CITY OF CODY
PLANNING, ZONING AND ADJUSTMENT BOARD
TUESDAY JUNE 28, 2022
CITY HALL COUNCIL CHAMBERS @ 12:00 NOON

MEETING DATE:	JUNE 28, 2022	TYPE OF ACTION NEEDED	
AGENDA ITEM:		P&Z BOARD APPROVAL:	
SUBJECT:	FINAL PLAT FOR THE DANSIE MINOR SUBDIVISION—A 3-LOT SUBDIVISION. SUB 2022-01	RECOMMENDATION TO COUNCIL:	X
PREPARED BY:	TODD STOWELL, CITY PLANNER	DISCUSSION ONLY:

MEETING DATE:	JUNE 28, 2022	TYPE OF ACTION NEEDED	
AGENDA ITEM:		P&Z BOARD APPROVAL:	
SUBJECT:	FINAL PLAT AND CONSTRUCTION PLANS FOR THE WEST AVENUE DUPLEXES SUBDIVISION— AN 8-LOT SUBDIVISION. SUB 2021-08	RECOMMENDATION TO COUNCIL:	X
PREPARED BY:	TODD STOWELL, CITY PLANNER	DISCUSSION ONLY:

OWNER:	CURT DANSIE	PROJECT:	DANSIE MINOR SUBDIVISION	SHEET	1 OF 1
		TITLE:	PLAN & PROFILE – ROADWAY

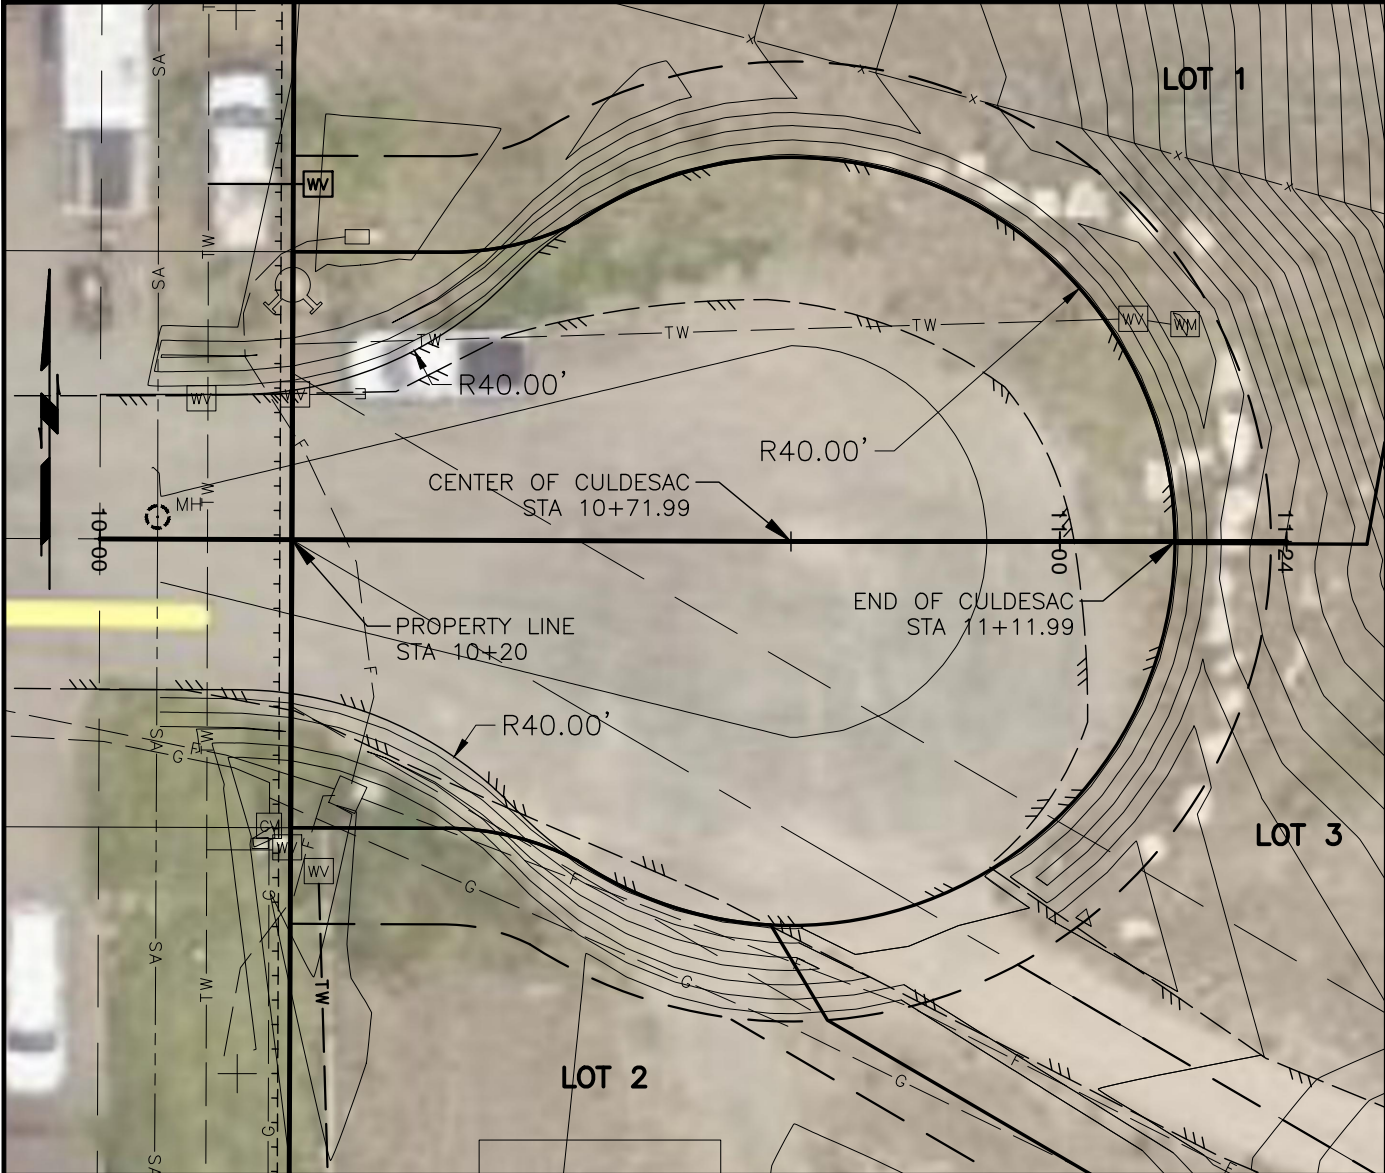
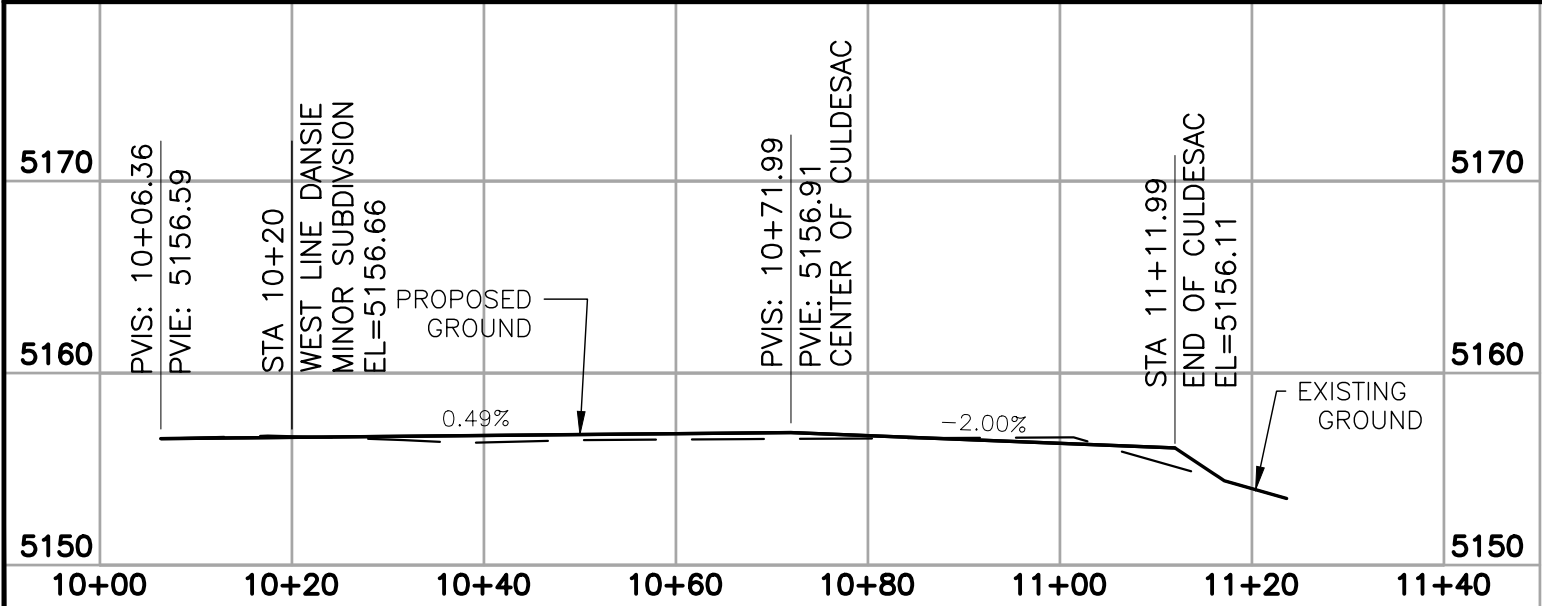
3. With the final plat application, provide grading and pavement detail plans of the cul-de-sac expansion for review and approval. Grading of a swale around appropriate portions of the perimeter (north side) is to be included. Construction of the expansion will need to occur prior to issuance of building permits on Lots 1 and 2; provided, a building permit may be issued if a financial security (e.g. letter of credit, performance bond, or cash deposit) is provided to the City to ensure completion prior to issuance of a certificate of occupancy.

Status: The plans have been submitted and are acceptable to Public Works.

Expansion of the cul-de-sac remains to be completed, so a note has been added to the plat (Note 2 in upper left corner) indicating that the installation of outstanding subdivision improvements is to be completed prior to issuance of building permits.

RAW WATER PLAN & PROFILE

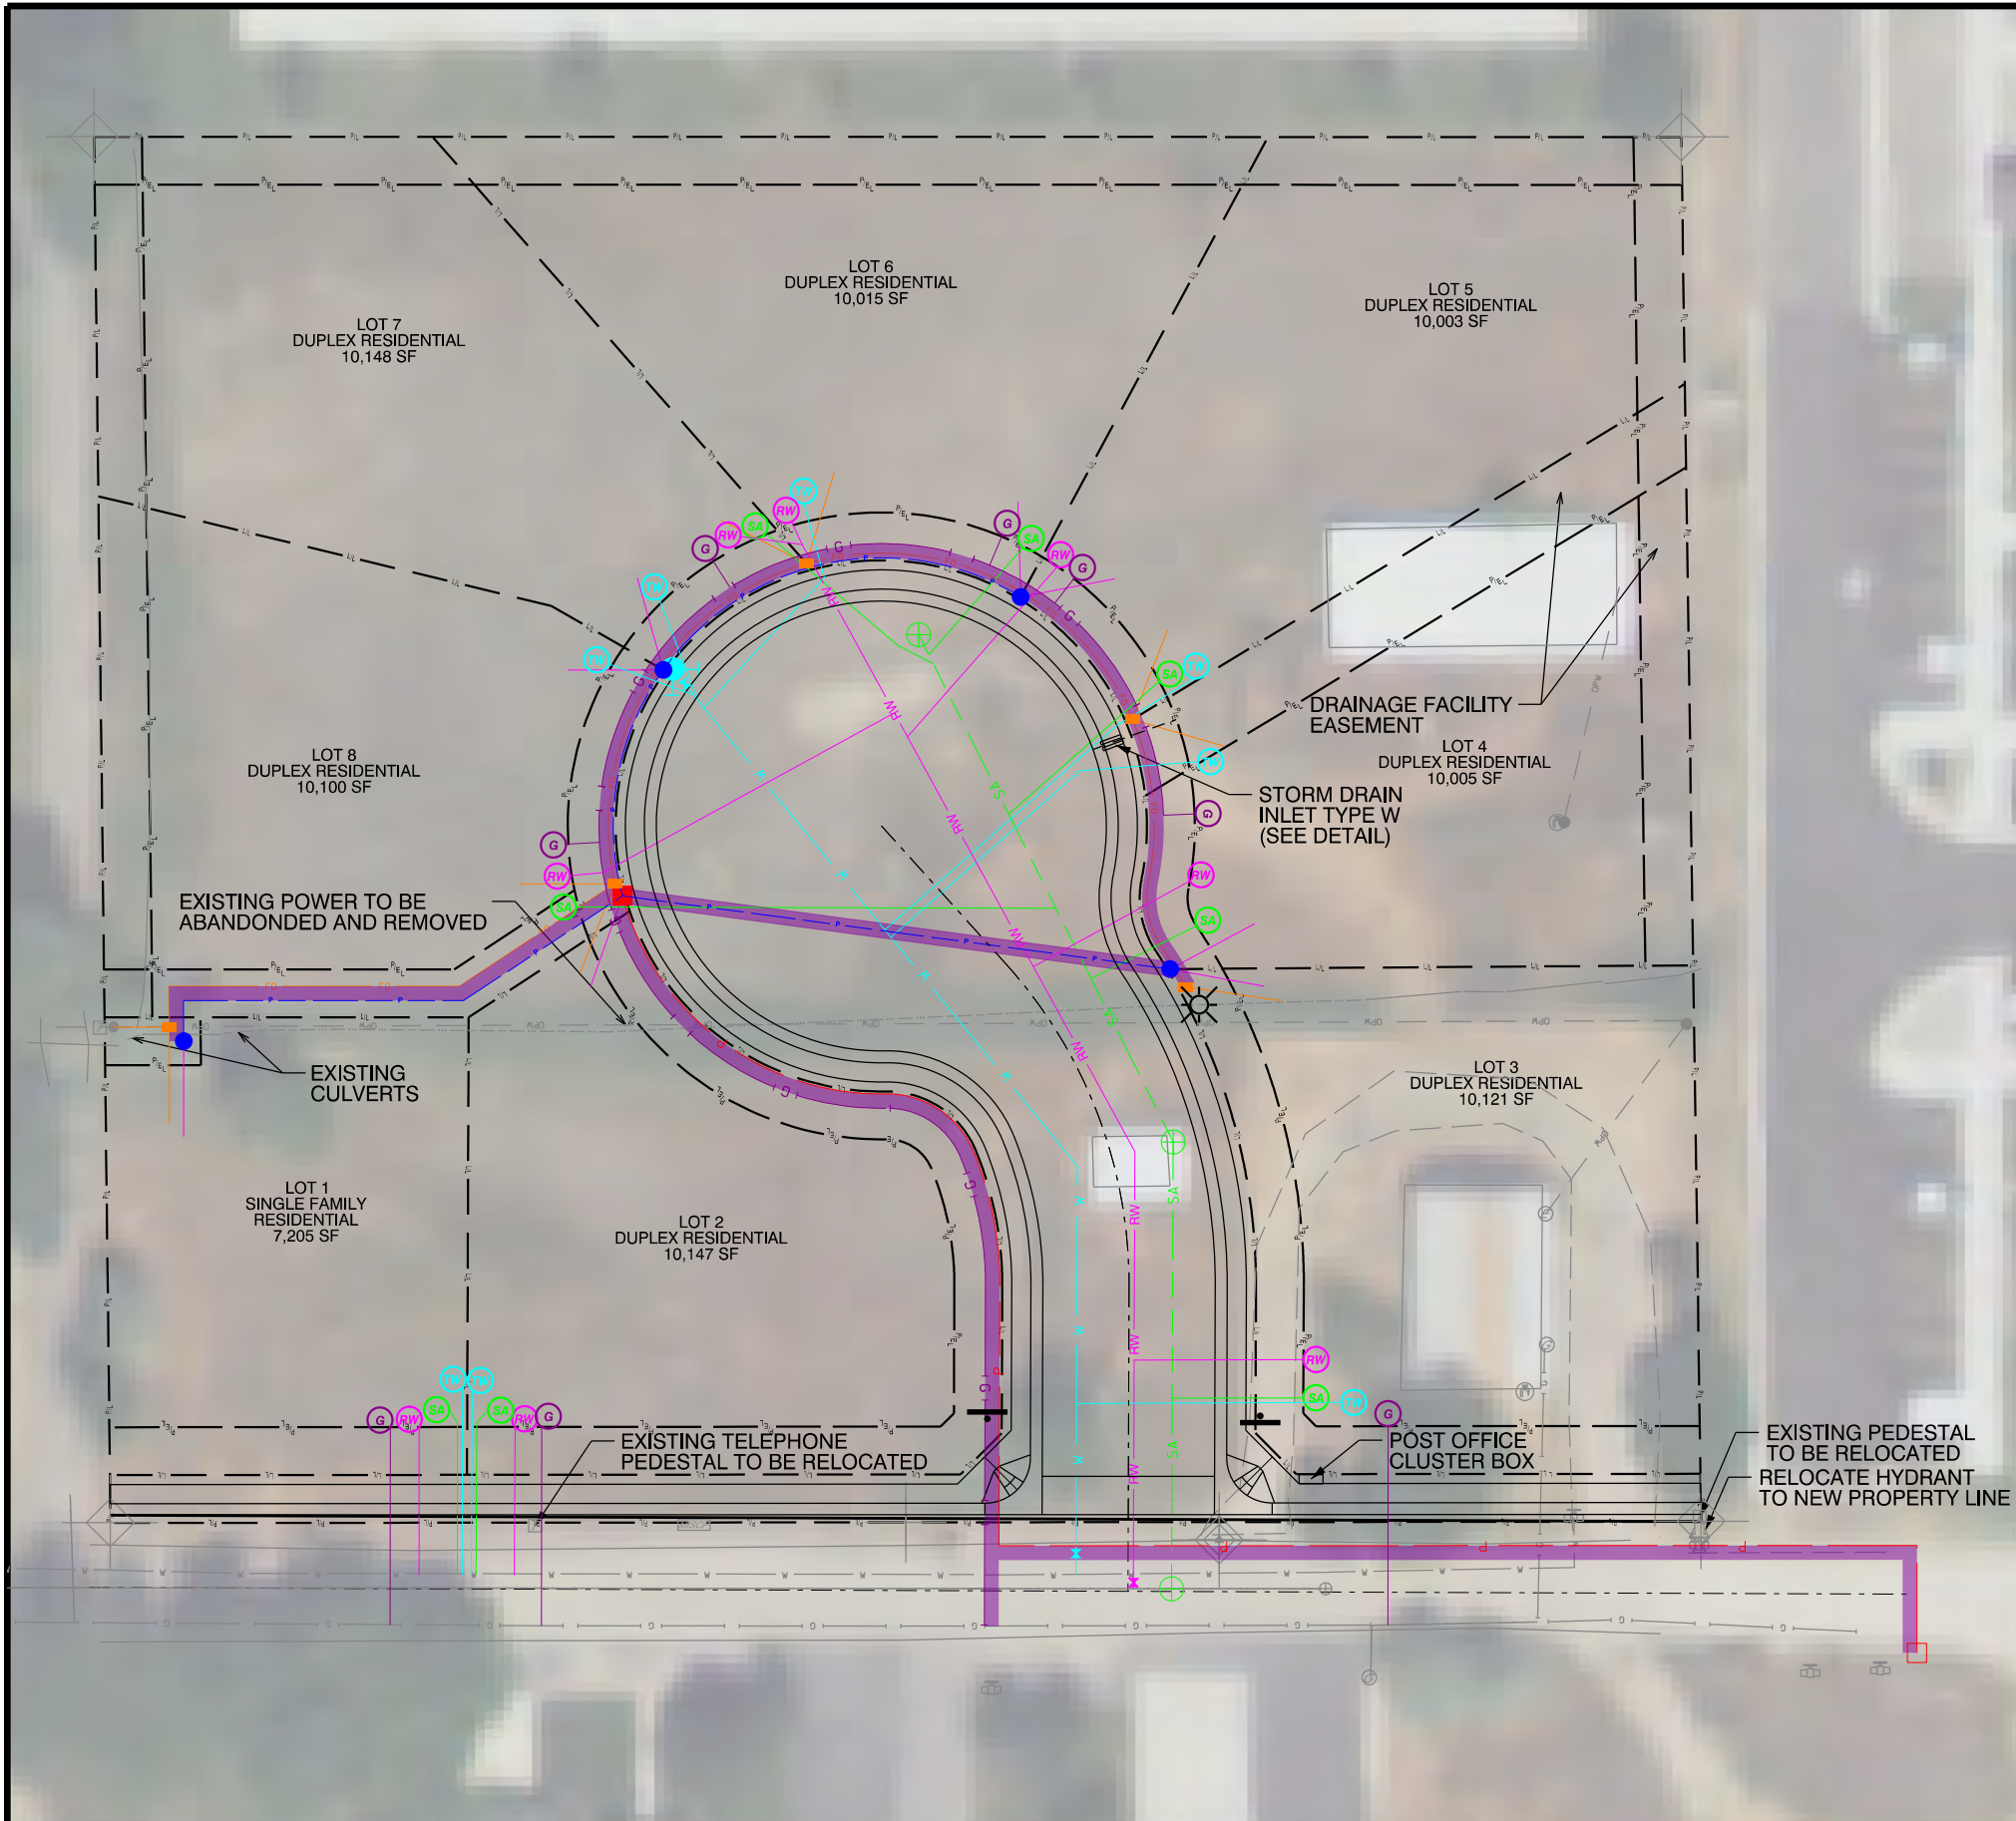
- b. Raw water valves are to be placed near the back of sidewalk. No pigtail is needed.

Status: The plans need corrected or clarified as the valves are not currently shown at the back of sidewalk. Due to the raw water drain location, raw water valves for Lots 6 and 7 may be on the back side of the dry utilities.
